Noise Feasibility Study
Proposed Residential Development
86 Thomas Street
City of Mississauga, Ontario

June 30, 2021

Appendix E: City of Mississauga Comments and HGC Responses

Figure 2: Site Plan Showing Prediction Locations

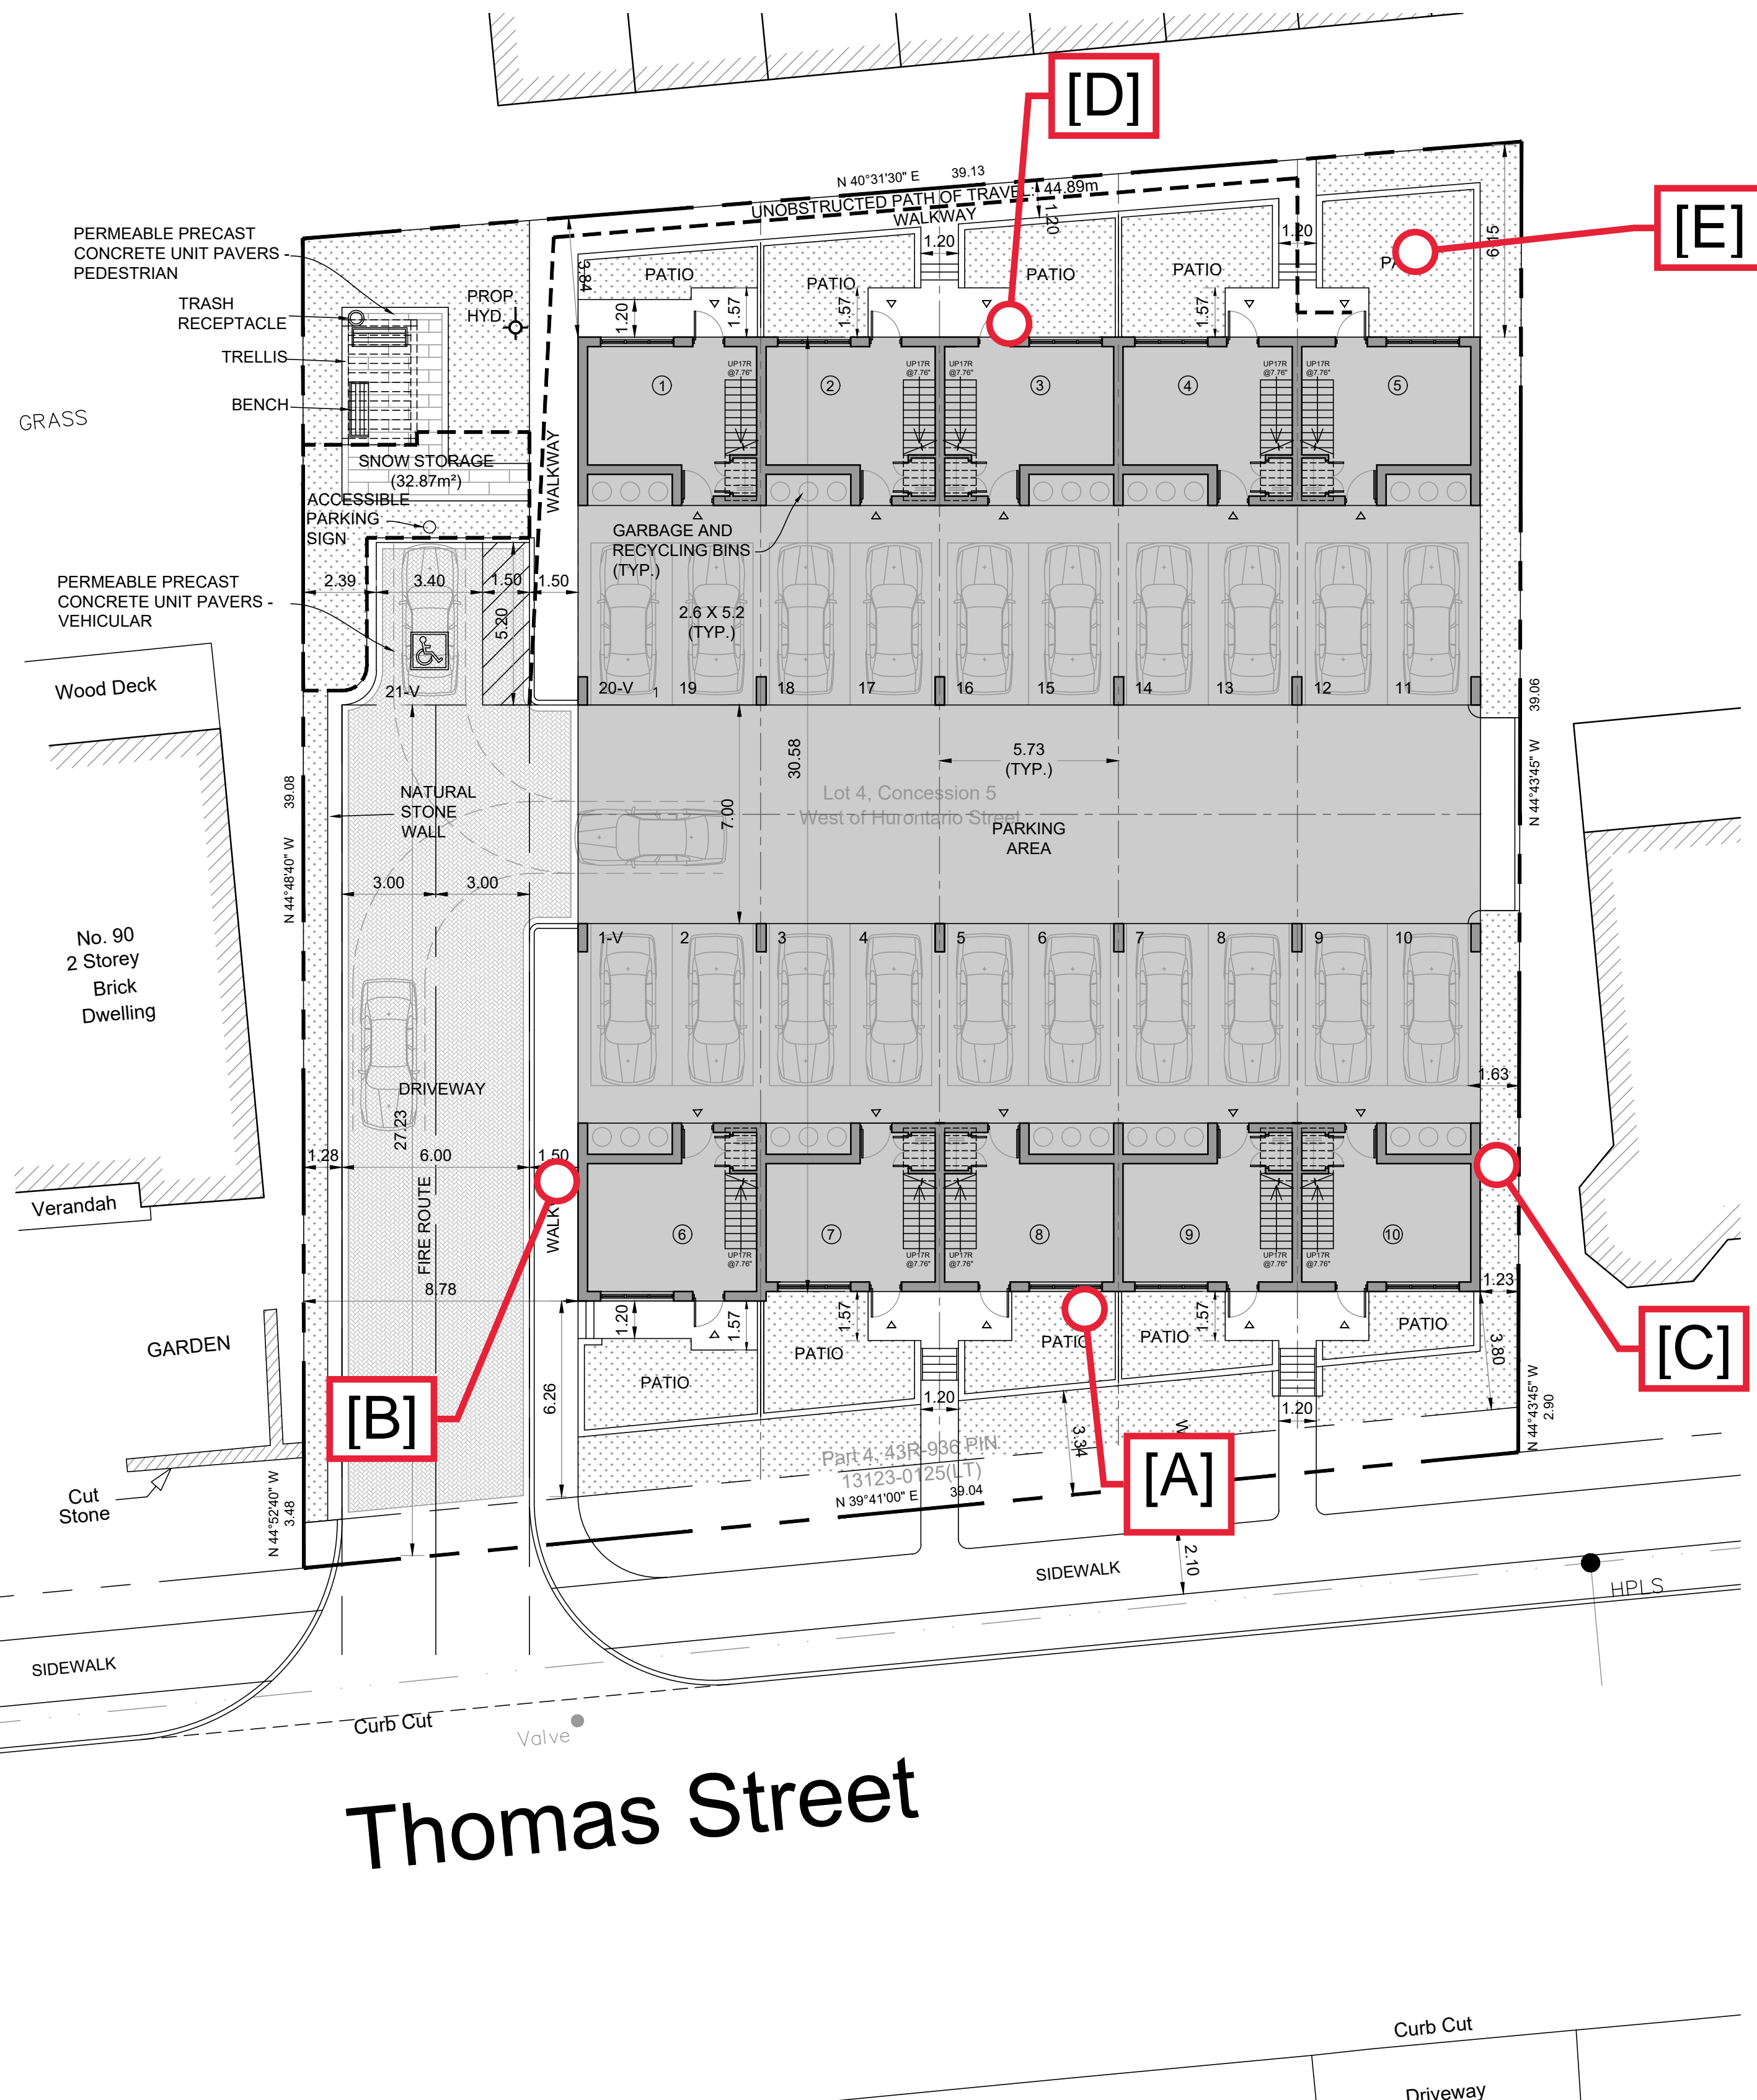
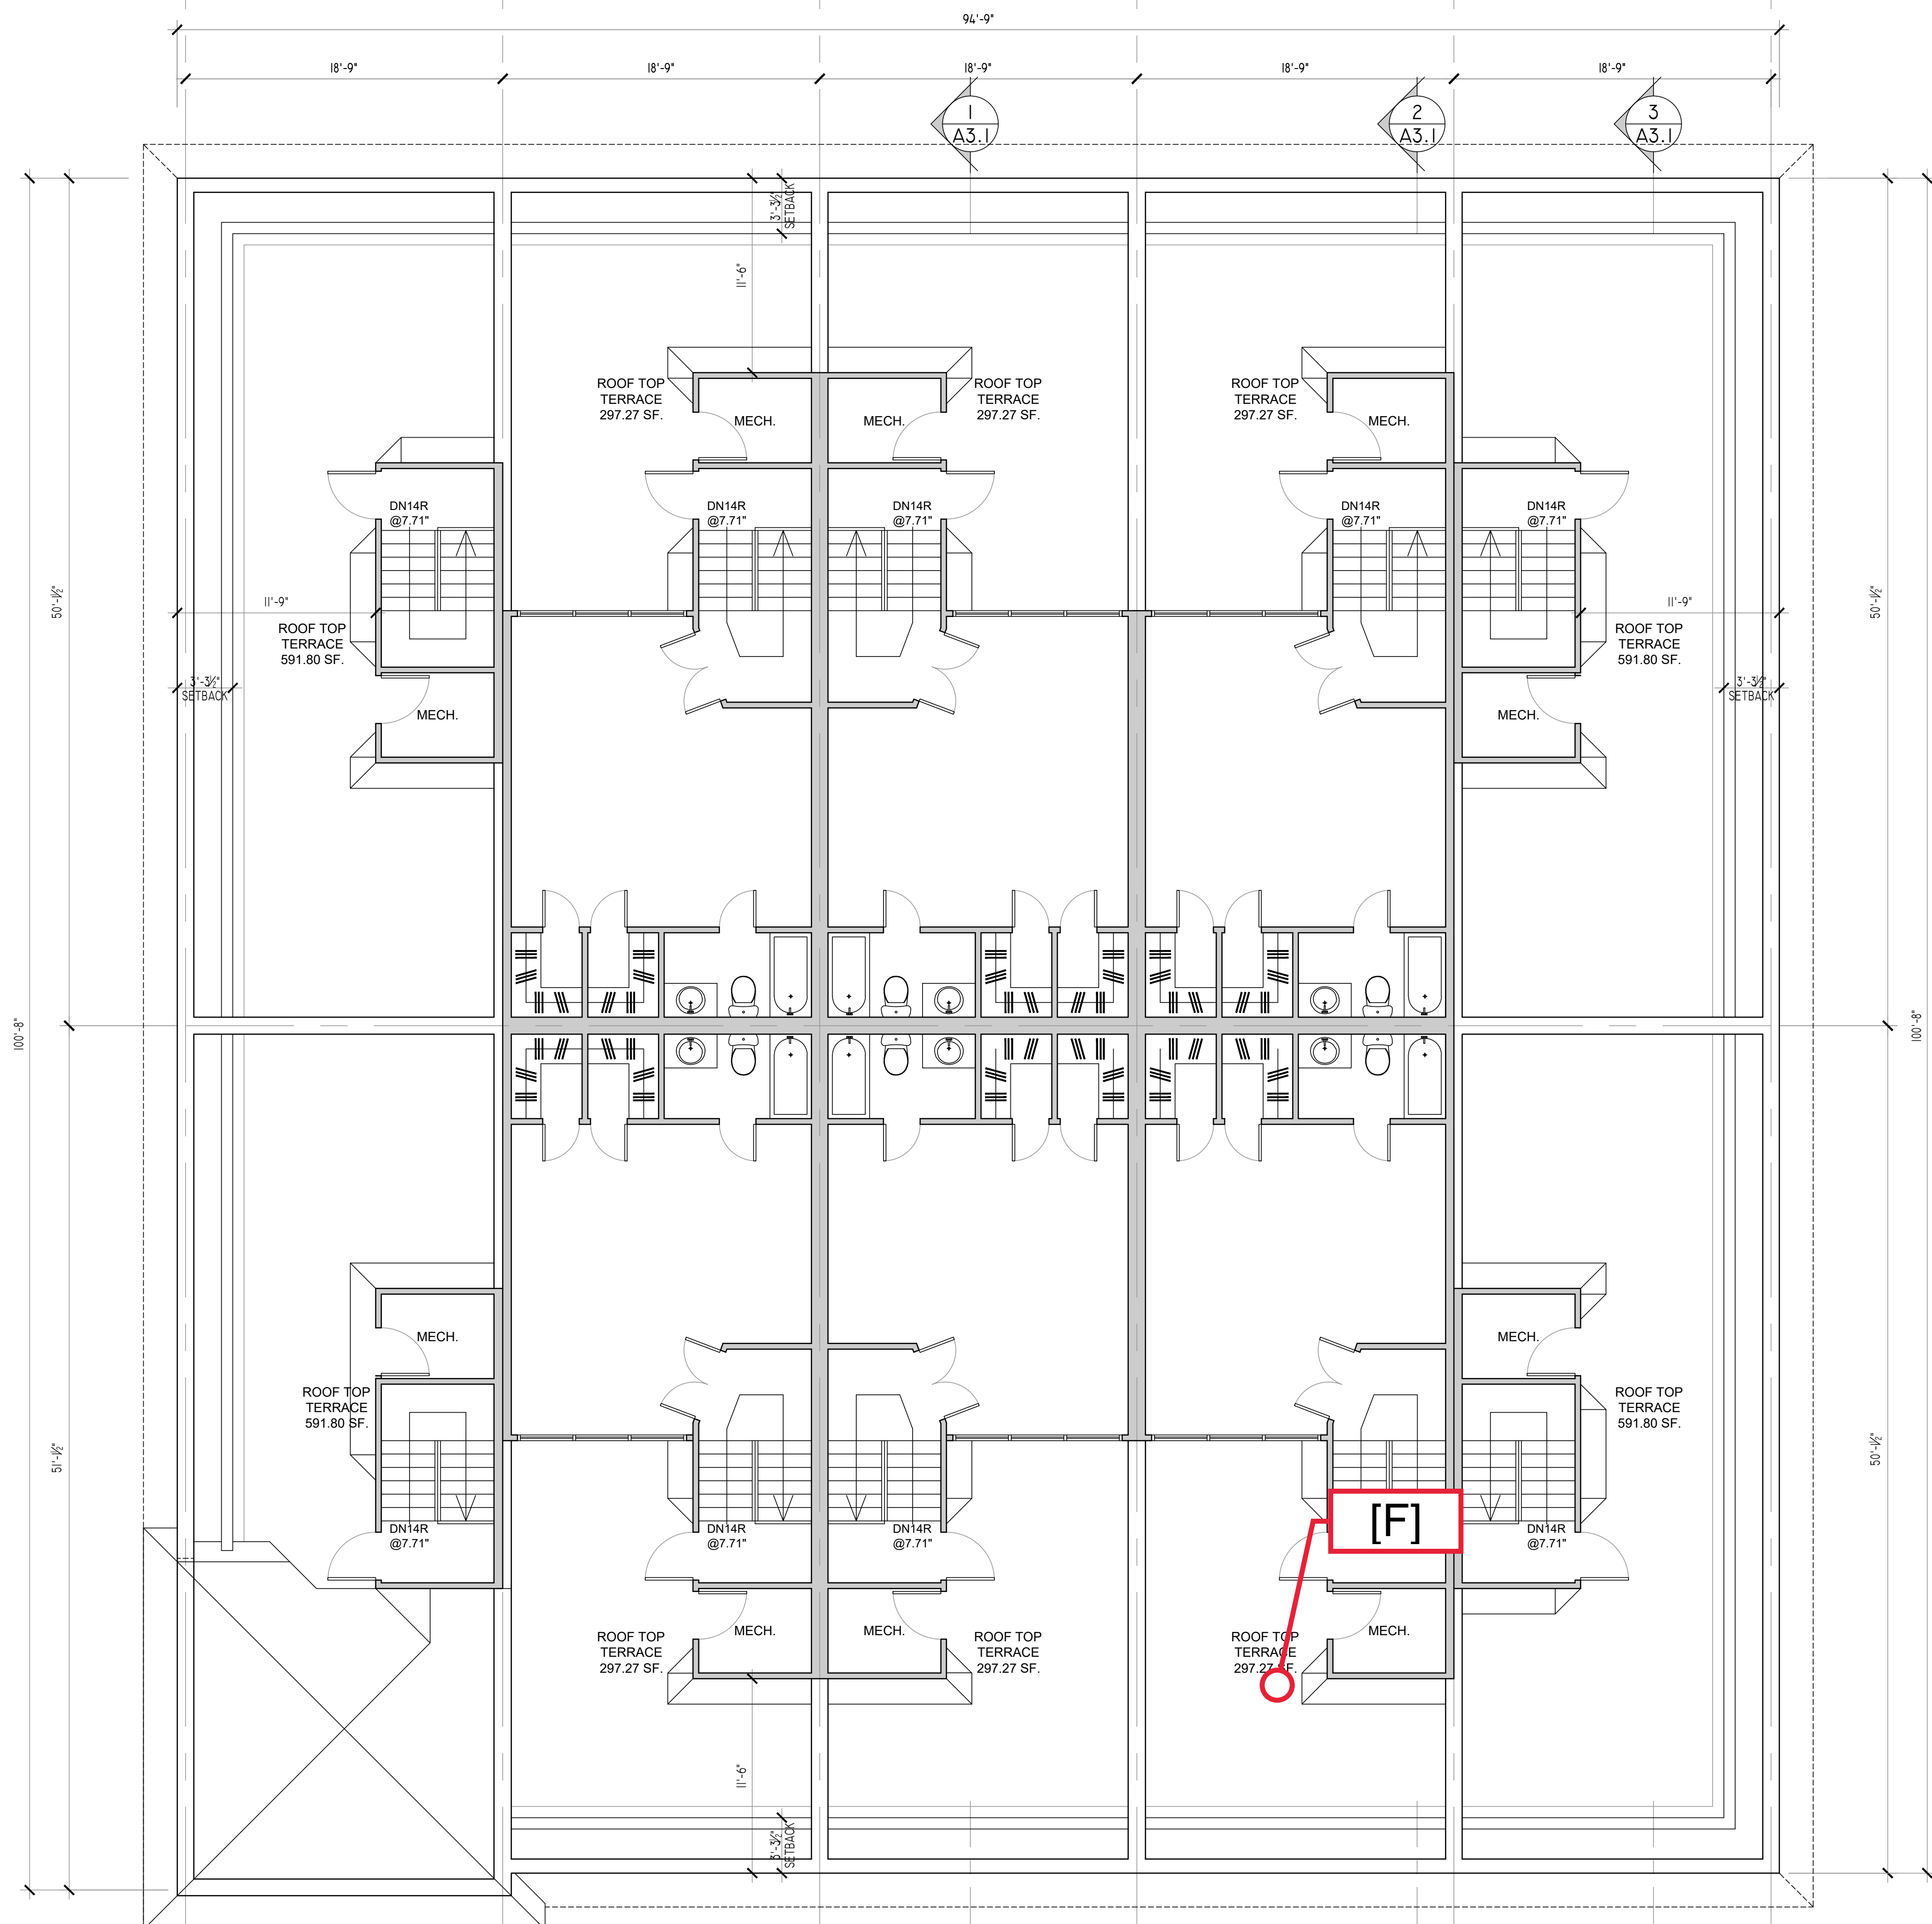
(i) The drawings received in support of this application show patios larger than 4 m for units 1,2, 6, 7 and 8. As such, the Noise Feasibility Study is to be updated to assess noise on those OLA's and update the report findings, recommendations and warning clauses as applicable. Further, if mitigation is required on those OLA's, the report is to provide a table depicting unmitigated sound levels and another separate table showing mitigated sound levels.

Noted. Patio areas are assessed using the latest site plan by Wes Surdyka Architect Inc. dated April 23, 2021. The elevated patio areas are less than 4 m in depth with the exception of the patio area of Unit 5, which was included in the analysis. Rooftop terrace OLAs were also assessed, as they were found to be greater than 4 m in depth.
